DOCKET 50-255 - LICENSE DRP-20 -
PALISADES PLANT - PROPOSED TECHNICAL
SPECIFICATION CHANGES RELATED
TO POWER DISTRIBUTION LIMITS

CONSUMERS POWER COMPANY
Docket 50-255
Request for Change to the Technical Specifications
License DPR-20

Figure
3-9

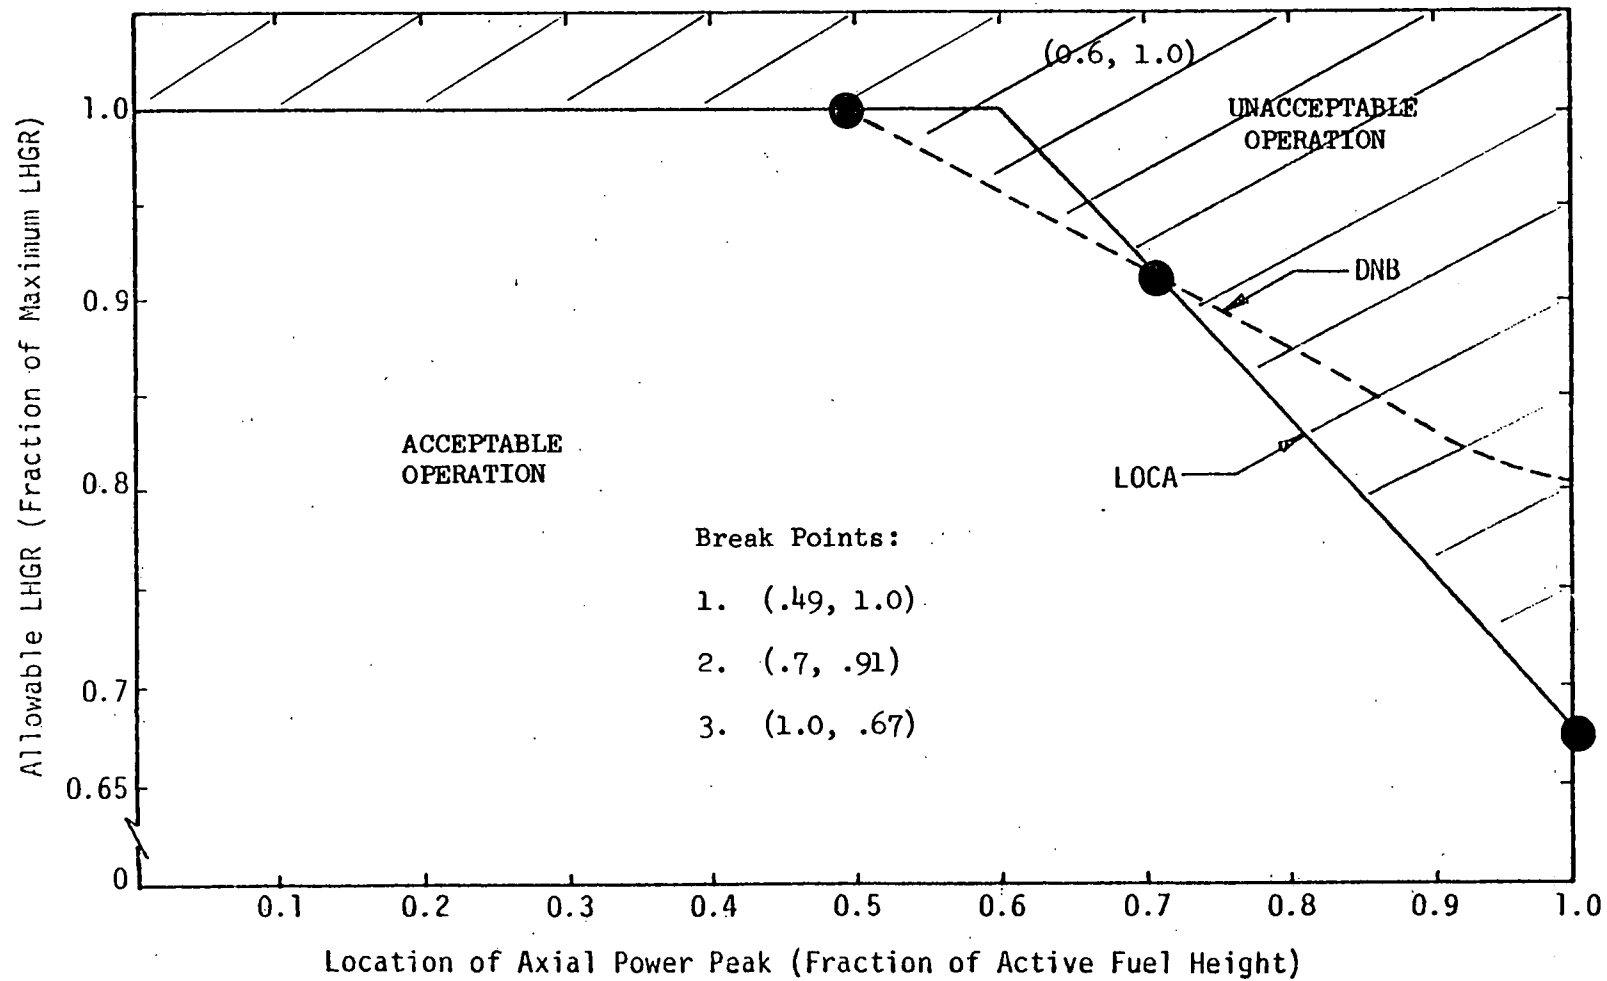
- A. Add new definitions for Assembly Radial Peaking Factor $-F_r^A$ and Total Radial Peaking Factor $-F_r^T$ to Section 1.1 as indicated on attached Technical Specification page changes.
- B. Delete references to Hot Channel Factors in Section 2.1 as indicated on attached Technical Specification page changes.
- C. Change Section 3.10.3.a as indicated on attached Technical Specification page changes.
- D. Add new Section 3.10.3.g as indicated on attached Technical Specification page changes.
- E. Change Basis for Section 3.10 as indicated on attached Technical Specification page changes.
- F. Add new Section 3.11.g as indicated on attached Technical Specification page changes.
- G. Delete Figures 3-7 and 3-8 and Replace Figure 3-9 with new 3-9 included in attached Technical Specification page changes.

- G. With the new Exxon analysis (XN-NF-78-16) and the inclusion in 3.10.3.a of various uncertainty factors Figures 3-7 and 3-8 are no longer required. The new Figure 3-9 is identical to Figure 2-1 of the Exxon report XN-NF-78-16.

where the function $F_A(Z)$ is shown in Figure 3.9. If the power distribution is double peaked, both peaks shall satisfy the criterion.
